RESPONSE TO REQUEST FOR ADDITIONAL INFORMATION

US-APWR Design Certification

RAI NO.: NO. 490-3732 REVISION 0
SRP SECTION: 03.08.01 – Concrete Containment
APPLICATION SECTION: 3.8.1
DATE OF RAI ISSUE: 11/23/2009

QUESTION NO. 03.08.01-09:

Figure 1 Section View and Stresses

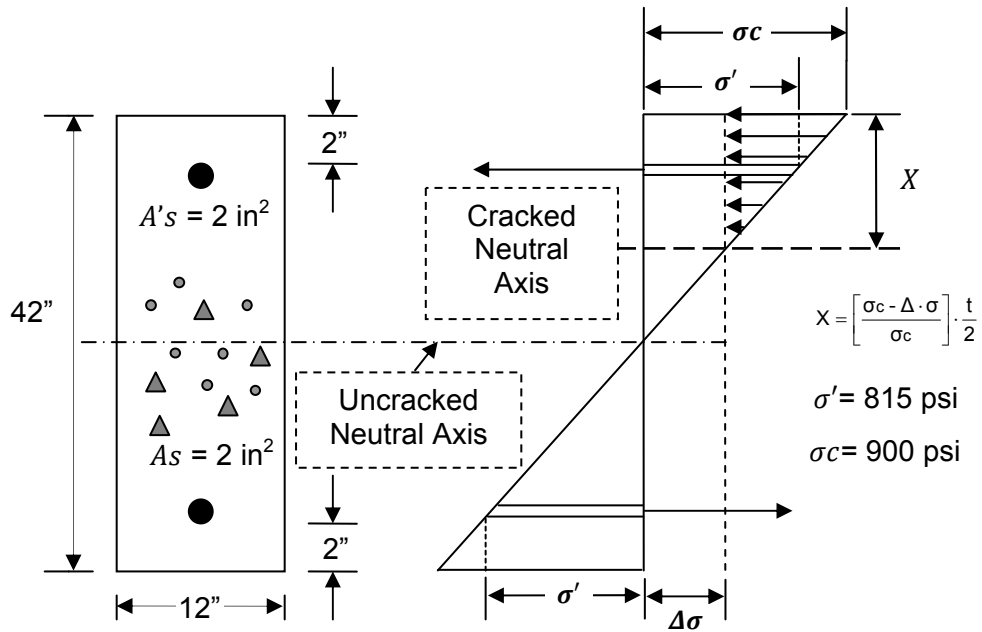
The staff finds that MHI's response does not clearly indicate how thermal forces and moments are reduced according to the concrete cracking depth. In MHI's response, a notation, σ_1 , is used to denote the extreme fiber stress of the concrete; however, in the example given at the end, an additional notation, σ_2 , is introduced without any explanation. MHI is requested to clarify this confusion. Also, MHI is requested to provide a calculation example that is taken from the US-APWR design, and that will have numerical results clearly showing the amount of reduction in forces and moments and the concrete cracking depth.

Due to changes in the US-APWR prestressed concrete containment vessel (PCCV) analysis and design approach, the variable, σ_2 , is no longer applicable. As before, the reduction is based on redistribution of section forces and moments that occurs from the concrete cracking. Concrete is considered to crack when the section is subject to tension and the neutral axis is shifted.

The following example is provided to show how concrete cracking in the PCCV cylindrical section is considered. The stress across a concrete section is calculated as an un-cracked

section initially and then the stress due to concrete cracking is calculated to adjust the concrete section given the effects of the cracked concrete behavior.

The example presented herein is an example of a PCCV concrete section when subjected to a thermal gradient with reinforcement provided on both faces and concrete cracking is considered.

Uncracked concrete stress, σ_c :

$$\sigma_c = \frac{1}{2} \alpha E c \Delta T = 900 \text{ psi}$$

Cracked concrete stress at rebar location, σ' :

$$\sigma' = \sigma_c \left(\frac{\frac{t}{2} - 2''}{\frac{t}{2}} \right)$$

$$\sigma' = 900 \left(\frac{21-2}{21} \right) = 814.3 \text{ psi, use } \sigma' = 815 \text{ psi}$$

Force Equilibrium to Solve for Change in Stress, $\Delta\sigma$:

Reinforcing Tension – Initial Concrete Compression Force + Concrete Compression Reduction = 0

$$Asfs - \frac{\sigma_c}{2} \left(\frac{t}{2} \right) b + \frac{\Delta\sigma b}{2} \left[\frac{t}{2} + \frac{t}{2} \left(\frac{\sigma_c - \Delta\sigma}{\sigma_c} \right) \right] = 0$$

The term $Asfs$ is adjusted due to stress shift where reinforcing steel stress in tension is subtracted by the amount of reinforcing steel stress in compression and is calculated as follows:

$$Asfs = As(fs - f's) = [As(\sigma' + \Delta\sigma)n - As(\sigma' - \Delta\sigma)(n - 1)]$$

Therefore, the change in stress, $\Delta\sigma$ is calculated as shown below.

$$2.0(815 + \Delta\sigma)10 - 2.0(815 - \Delta\sigma)(10 - 1) - \frac{900}{2}(21)(12) + \Delta\sigma\left(\frac{12}{2}\right)\left[21 + 21\left(\frac{900 - \Delta\sigma}{900}\right)\right] = 0$$

$$\Delta\sigma = 511.9 \text{ psi, use } \Delta\sigma = 512 \text{ psi}$$

The tension and compression reinforcement along with the concrete compression stress are adjusted with the $\Delta\sigma$ value calculated previously to account for concrete cracking condition. The tension and compression reinforcement and concrete compression stress are adjusted as follows:

The addition of compression reinforcing has increased the stress in the tensile reinforcing from 12,860 psi to 13,270 psi due to the compression reinforcing expanding from the applied thermal gradient. If the gradient is applied over a long period of time, the concrete section will creep in the compressive zone, relieving concrete stress, but increasing the compression reinforcing steel stress. The tensile reinforcing stress can be calculated by adjusting the outside reinforcing modular ratio, n .

Due to the effects of concrete cracking have on the cross section, the neutral axis is shifted to reflect such conditions. The cracked neutral axis is therefore calculated as follows.

Cracked Neutral Axis, X

$$X = \left(\frac{\sigma_c - \Delta\sigma}{\sigma_c}\right) \frac{t}{2} = \left(\frac{388}{900}\right) 21 = 9.05 \text{ in.}$$
